**Re: Petition for Modifications No. 1, Walnut Creek Energy Park (05-AC-02)**

*Petition for Modification No. 1*

**Minor Equipment Location Changes**

**Walnut Creek Energy Park**

**FIGURE 2.1-1A**  
**Revised EME Walnut Creek**  
**Energy Park General Arrangement**  
 Walnut Creek Energy Park Modification 1  
 Walnut Creek, California

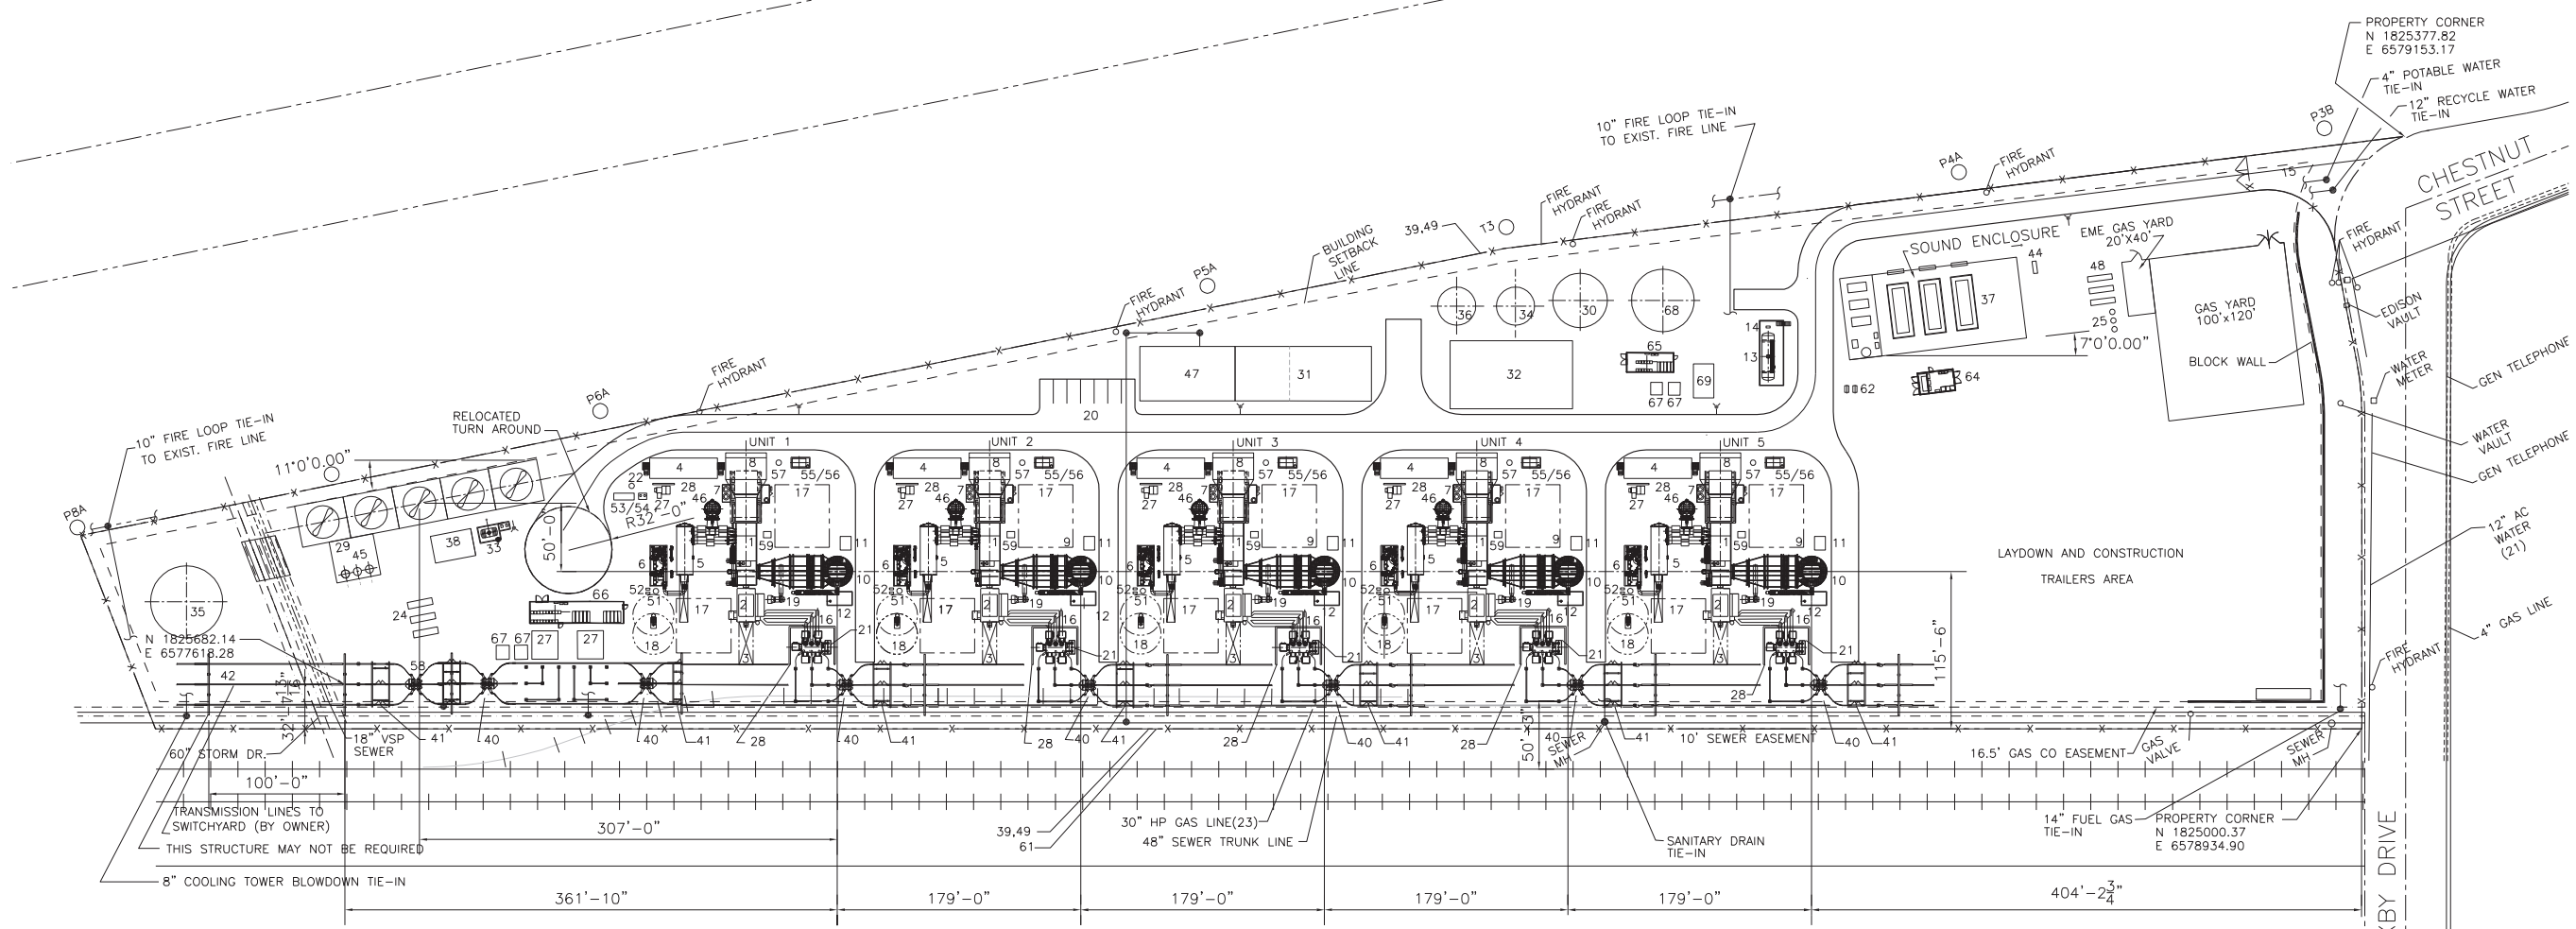
- Per direction from the Los Angeles County Fire Department, a turnaround circle will be added to the end of the facility driveway at the northern end of the site. To make room for the turnaround circle, the gas compressor building (37) will be moved from the western end of the project site, near the power distribution center (66), to the eastern end of the project site.

- A gas metering yard and filters will be located adjacent to the gas company yard on the east end of the project site.
- The cooling tower (29) will be moved approximately 120 feet east of the location identified in the AFC.

- The wastewater storage tank (35) will be added to the far west end of the site. The tank will be located near the cooling tower location.
- The control building and the warehouse/maintenance building will be combined into one building (47 and 31).

- The recycled chlorination tank will be removed.
- Miscellaneous small equipment will be added (51 to 68).
- Five high-side electrical breakers (40) will be added along the southwest side of the site.

**FIGURE 2.1-1B**  
**Comparison of the Proposed EME Walnut Creek Energy Park (WCEP) General Arrangement to the EME WCEP AFC General Arrangement**  
Walnut Creek Energy Park Modification 1  
Walnut Creek, California

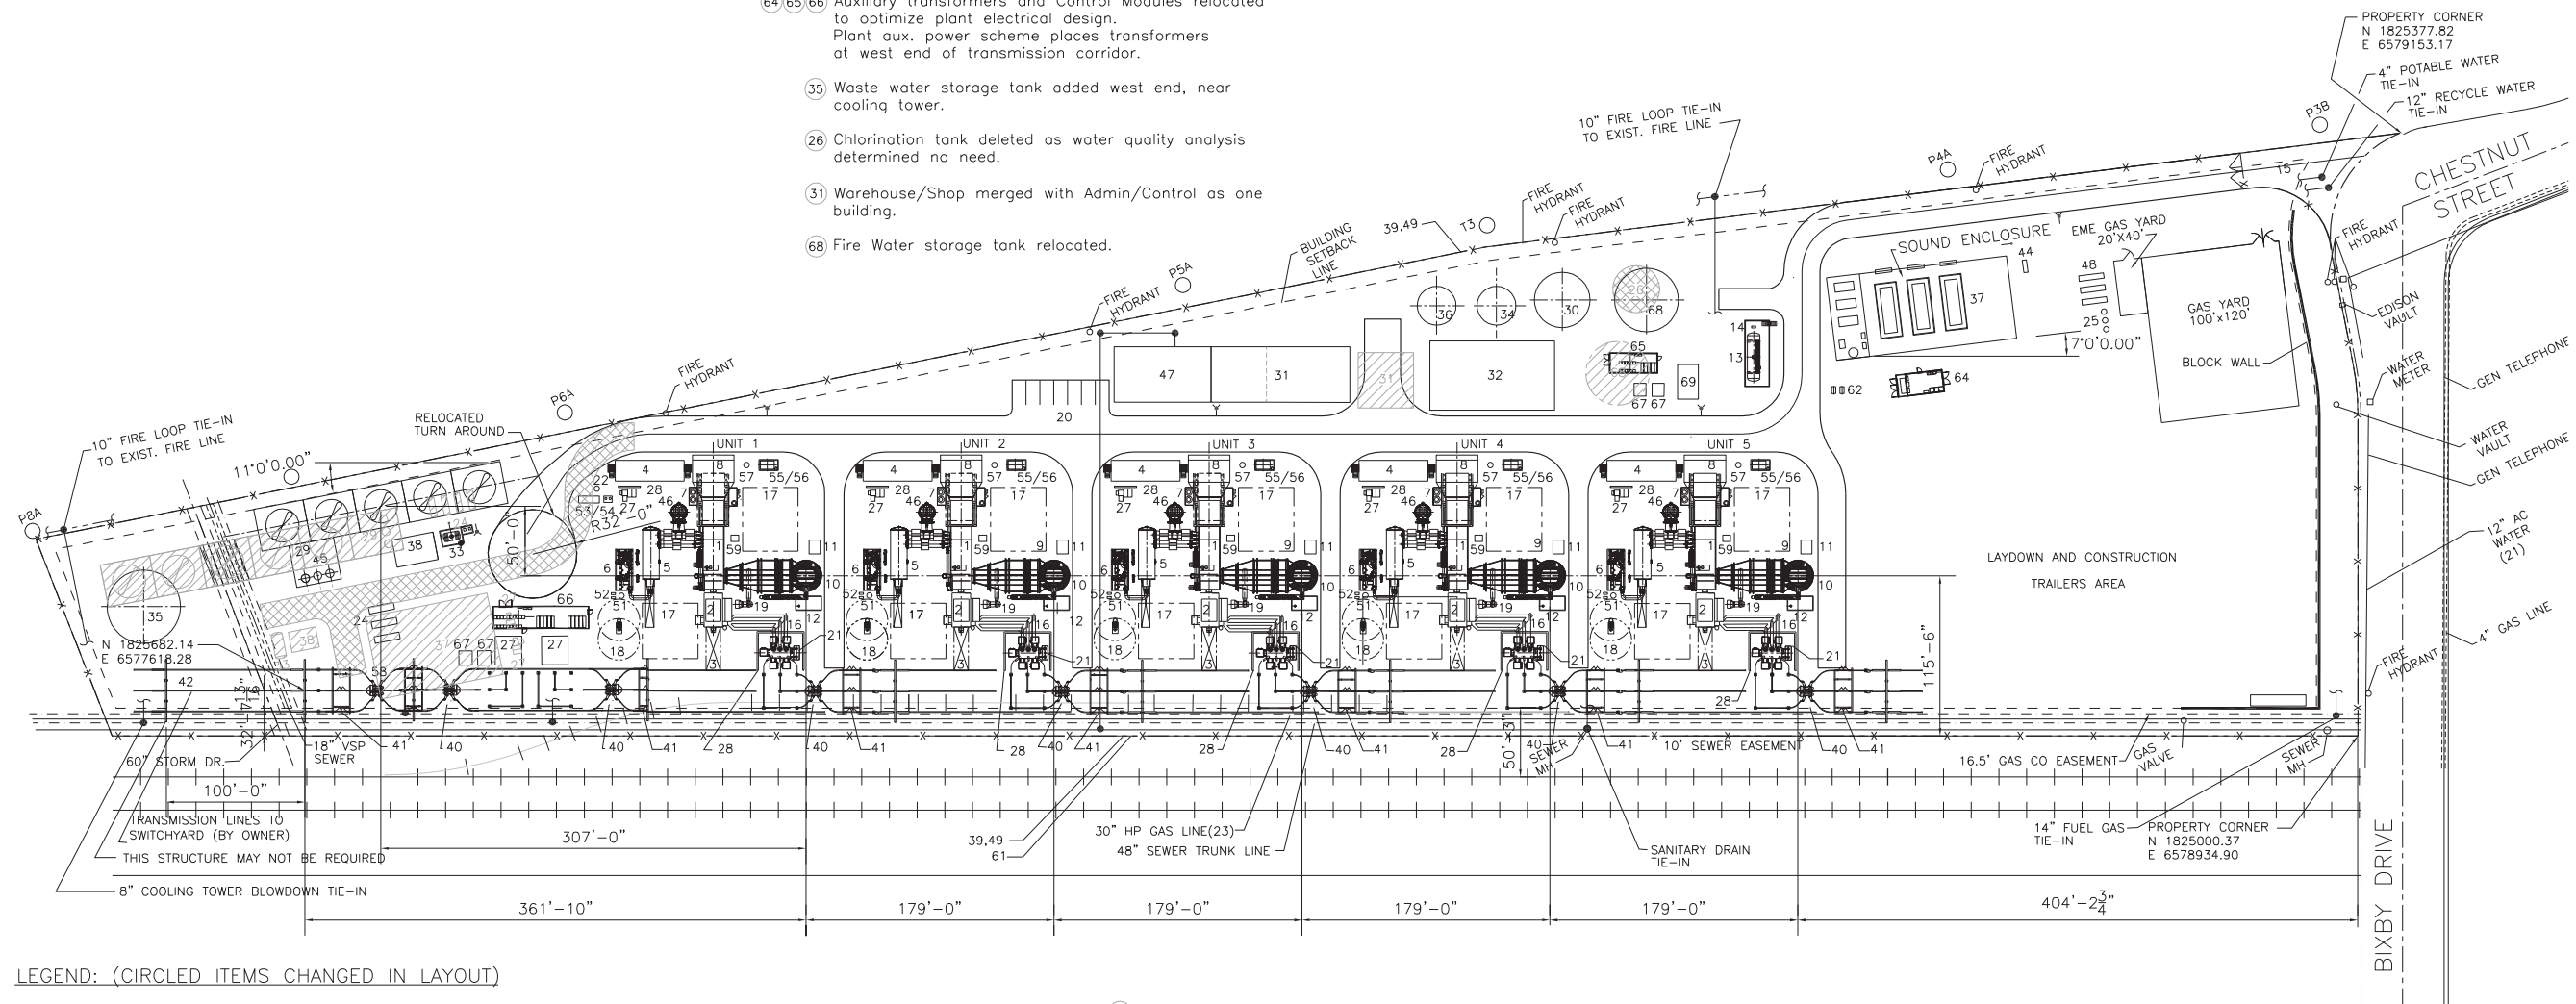
- Roadway revised at west end to allow space for equipment relocation and provide traffic turn-around.
- (24) (29) (38) (45) Cooling tower shifted east, off existing underground pipe corridor, pump basin placed on long side.
- (25) (37) (48) Natural Gas equipment and enclosure relocated east and north.
- (64) (65) (66) Auxiliary transformers and Control Modules relocated to optimize plant electrical design. Plant aux. power scheme places transformers at west end of transmission corridor.
- (35) Waste water storage tank added west end, near cooling tower.
- (26) Chlorination tank deleted as water quality analysis determined no need.
- (31) Warehouse/Shop merged with Admin/Control as one building.
- (68) Fire Water storage tank relocated.

**FIGURE 2.1-2**  
**Revised EME Walnut Creek Energy Park**  
**Elevation Drawing**  
 Walnut Creek Energy Park Modification 1  
 Walnut Creek, California

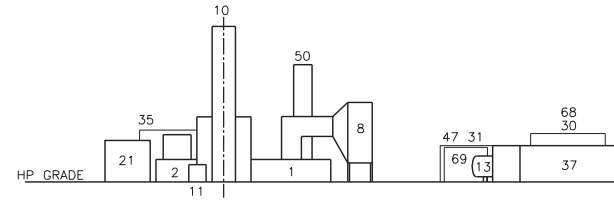
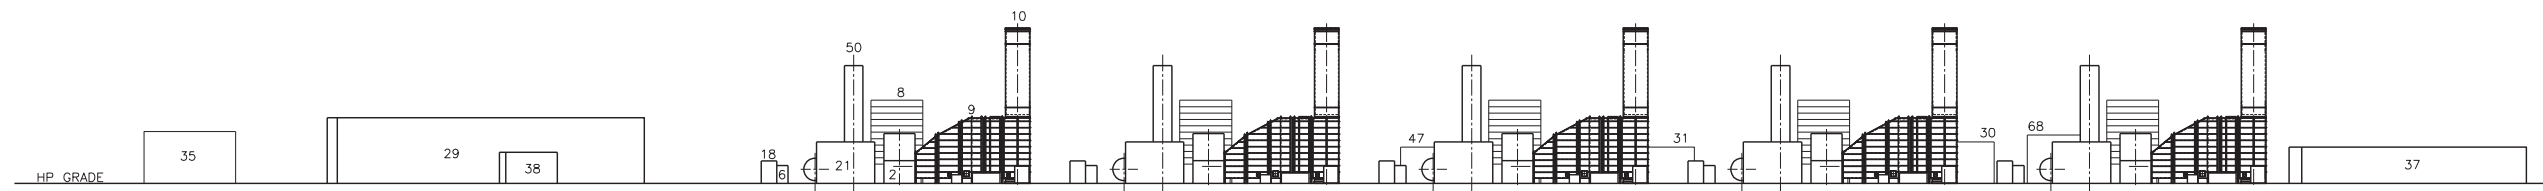
This section includes a description of the proposed project modifications, consistent with CEC Siting Regulations (Title 20, CCR, Section 1769 [a][1][A]). Walnut Creek Energy, LLC proposes to modify the previous project layout to accommodate the development of the project and optimize the arrangement of the facility equipment. Figure 2.1-1a presents the revised general arrangement drawing. Figure 2.1-1b presents a comparison of the proposed modifications to the general arrangement drawing included in the AFC. Figure 2.1-2 shows the profile view (elevation) of the project design, as revised.

FIGURE 3.1-1  
Revised ISCST3 Building Location Plot

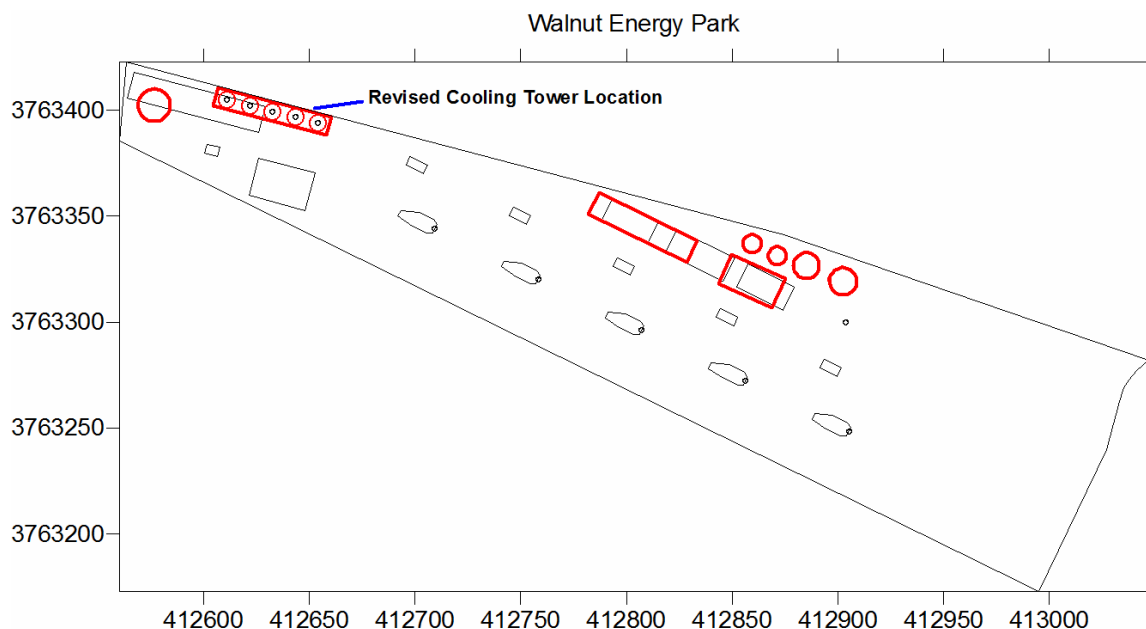
WCE proposes to move the WCEP cooling tower approximately 120 feet to the east, which would place it closer to the LMS-100 turbines. To assess the potential for changes to the project air quality and health risk impacts, the new cooling tower location was analyzed with both the Industrial Source Complex Short Term Model (ISCST3) as well as the Hotspot Analysis Reporting Program (HARP). As part of the inputs into both models, the Building Profile Input Program (BPIP) was also used to calculate the revised structure dimensions based on the new location of the cooling tower. No other changes to emissions or source locations are proposed for the WCEP. The revised cooling tower location used in the ISCST3 dispersion modeling analysis is depicted in Figure 3.1-1.
